## CRD table of comments and responses to NPA 2013-07

## (General Comments)

# AMC 20-20 Amdt 1 'Continuing Structural Integrity Programme' — 10. LIMIT OF VALIDITY OF THE MAINTENANCE PROGRAMME AND EVALUATION FOR WIDESPREAD FATIGUE DAMAGE — (b) Revision of WFD evaluation and LoV

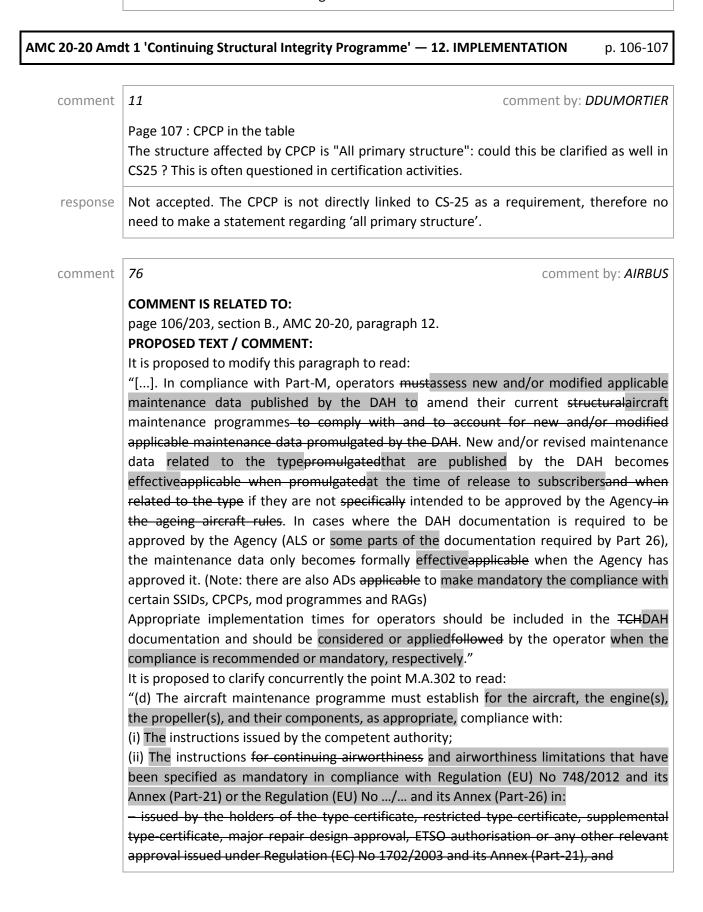
comment	263 comment by: AIRBUS
	Comment related to page 105/203, paragraph (b) PROPOSED TEXT / COMMENT: It is proposed to modify this paragraph to read: In order to operate an individual aircraft up to an extended LoV, a WFD evaluation should also be performed for all applicable modified or repaired structure to determine if any new structure or any structure affected by the change is susceptible to WFD. This evaluation should be conducted by the DAH for the changed structure in conjunction with the operator prior to the aircraft reaching its existing LoV. For practical purposes it is suggested that the SRM is also reviewed and updated to facilitate its continued applicability up to the extended LoV. If this is not done all SRM-based repairs will require individual approval. RATIONALE / REASON / JUSTIFICATION: For harmonisation with FAA proposal and single process
